TECHNICAL SERVICE BULLETIN

Bulletin No.: TSB-049
Date: July 19, 2023
Subject: VP Trailer Flex Plate and Sleeve Wear
Models: Quantum 20', 40', 45' Virtual Pipeline Trailers

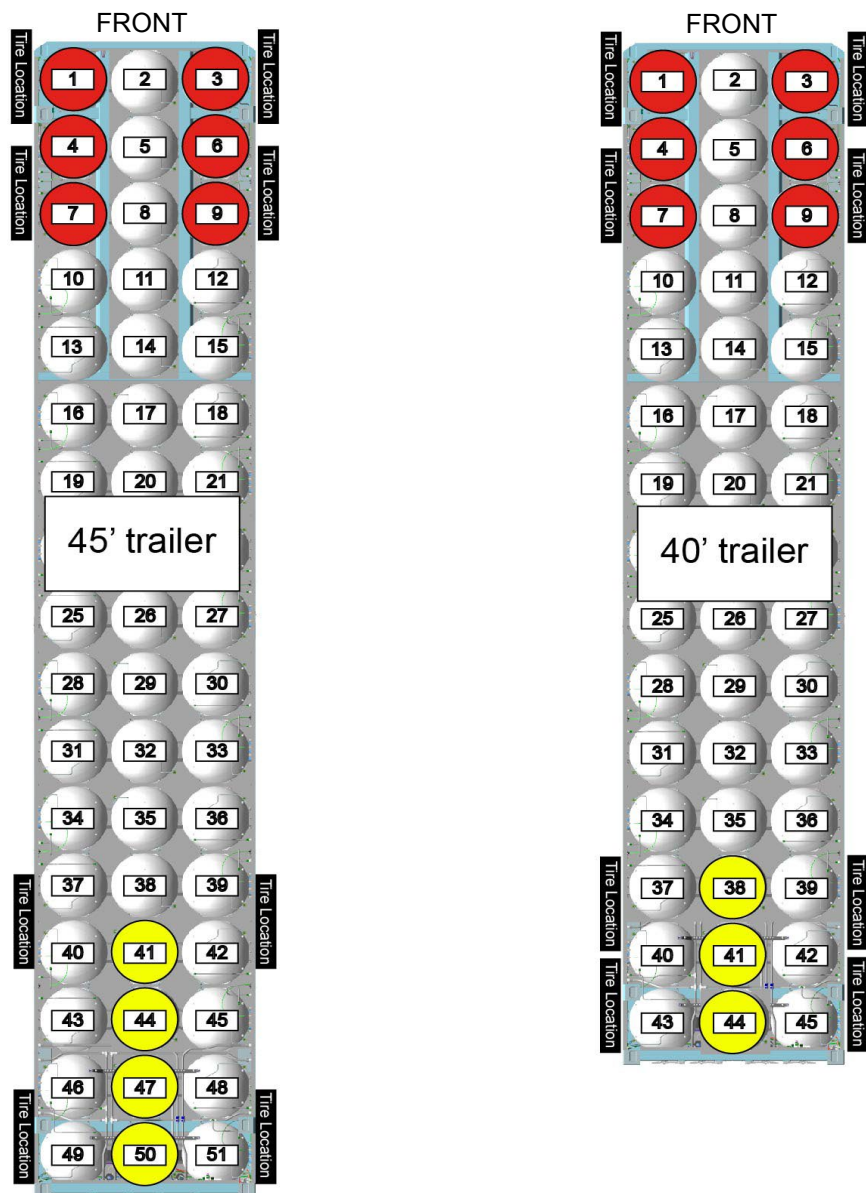
Dirt and debris from the road is picked up by the tires and thrown into the container mountings through the vent openings in the lower panels. This continuous contaminate introduction is responsible for the accelerated wear of the components in this area.

The outside cylinders in the front of the trailer (shown in red), are typically impacted by this concern due to the proximity directly above the tractor tires. To date there have been no reported wear concerns of flex plates or sleeves on the center cylinders in the front of the trailer.

The cylinders in the center of the trailer near the rear (shown in yellow) may experience accelerated wear due to splash from the trailer tires, but to a much lesser extent. The fenders on the trailer itself protect the cylinders directly above the trailer tires.

Inspect the lower cylinder mountings indicated in red by the illustration in this document, if wear is observed on any cylinder sleeve or flex plate, replace the flex and sleeve on the front outside cylinders with the revised flex plate assembly.

This revised flex plate assembly will be installed on the front three rows of cylinders, on the right-hand and left-hand sides above the tractor tires. The replacement of the flex plates in these positions will be completed at no cost to the customer, on trailers that experience concerns within the standard trailer one (1) year warranty period.
